SITE PLAN/SPECIAL PERMIT EVALUATION

44 Three Mile Harbor Road SCTM#300-161-4-9 App#: A0520200021

Prepared by: Marco Wu MW

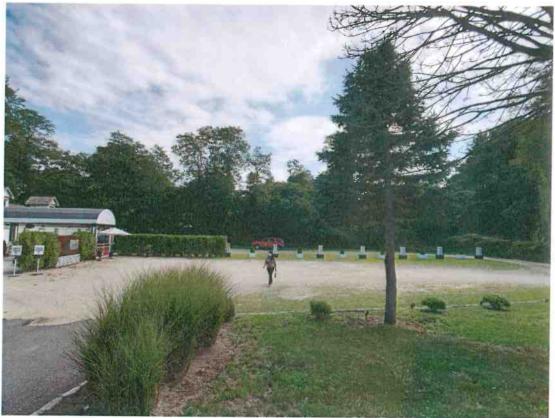
Application to build a mixed use building (retail, office, affordable apartments) with new at grade and underground parking, demolish the existing structures.

Existing building

Existing access points and frontage along CR40

Existing lot

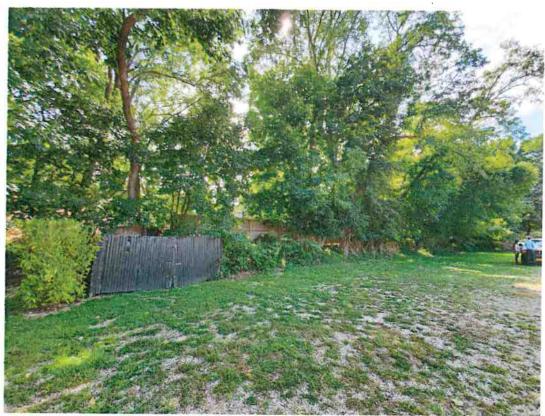
The building envelope depicted on the site plan does not take into account the requirement that the side and rear yard setbacks must be doubled where the site borders residence districts as per §255-11-10 Business and Commercial-Industrial Districts - Table of Dimensional Regulations (Note 7 - Except for yards bordering a residence district, in which case the figure shown shall be doubled.) Therefore, the setbacks for principal and accessory structures are doubled to 30' on the southerly side and to 50' on the easterly or rear side.

A small portion of the existing building is preexisting, nonconforming with regard to setbacks on the northern and eastern side. The proposed building is oriented to be parallel

to the western property line (Three Mile Harbor Road) and a significant portion of the building falls within the 50' rear yard setback requirement and would require a variance from the Zoning Board of Appeals. Similarly a significant portion of the building will fall within the 30' side yard setback requirement along the northern side of the property and would also require a variance.

The parking proposed on the southerly side is proposed on the property line and does not meet the 30' setback requirement based on the doubled setbacks as it adjoins a residential district. The parking proposed along Three Mile Harbor Road is also located along the property line and does not meet the 25' front yard setback requirement. The Board would have the ability to relax these setbacks pursuant to §255-6-63 (See attached) if it found that this was in the interest of good planning. The standard for such are also attached. It is noted that the Town Code encourages and it has been a Planning Board policy not to place parking directly along the road in front of a building.

Existing structure is preexisting and nonconforming to setbacks. Proposed structure will be within setbacks on all sides.

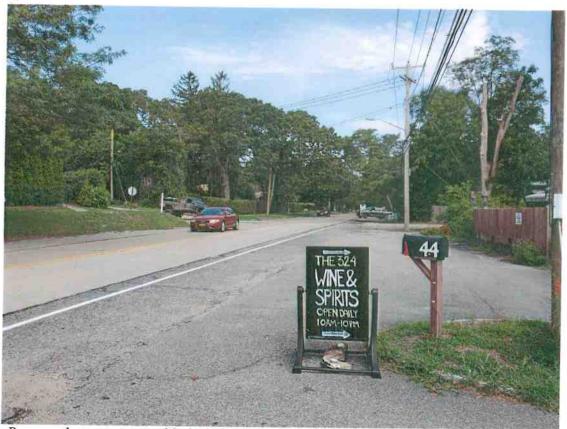
Parking calculations provided on the plan indicate that 86 spaces are required, however it is noted that 87 spaces are required pursuant to §255-2-45 of the Town Code, 49 for the retail use, 30 for the office use, and 8 for the housing units. The plans show that only 59 of the 87 required spaces are being provided, 36 at grade and 23 below grade in an underground parking garage. This would result in the requirement for a significant variance from the Zoning Board of Appeals and a shortage in parking.

The Planning Department has noted that certain parts of the aisles for the vehicle parking at grade, and underground are fairly narrow and could make turning difficult for those maneuvering within the lots. Upon review, the certain spaces at grade and in the underground parking lot do not meet the proper design requirements pursuant to §255-11-43 Subsection C (See attached) Under the design requirements, all aisles within parking areas shall have a minimum width of 24 feet when the parking spaces are an a ninety-degree angle with the aisle. Other widths are recommended if parking spaces are proposed at different angles as mentioned further in the code. Given the aforementioned, it appears at least 4 of the proposed spaces at grade level, and at least 12 spaces within the underground parking lot do not meet the 24' width requirement for the parking aisle. This would result in a lesser number of spaces provided in addition to the proposal's current offering that does not meet the minimum parking requirement.

The proposal is short of their parking requirements, and will need to widen the aisle for vehicles to meet Town Code Design Standards.
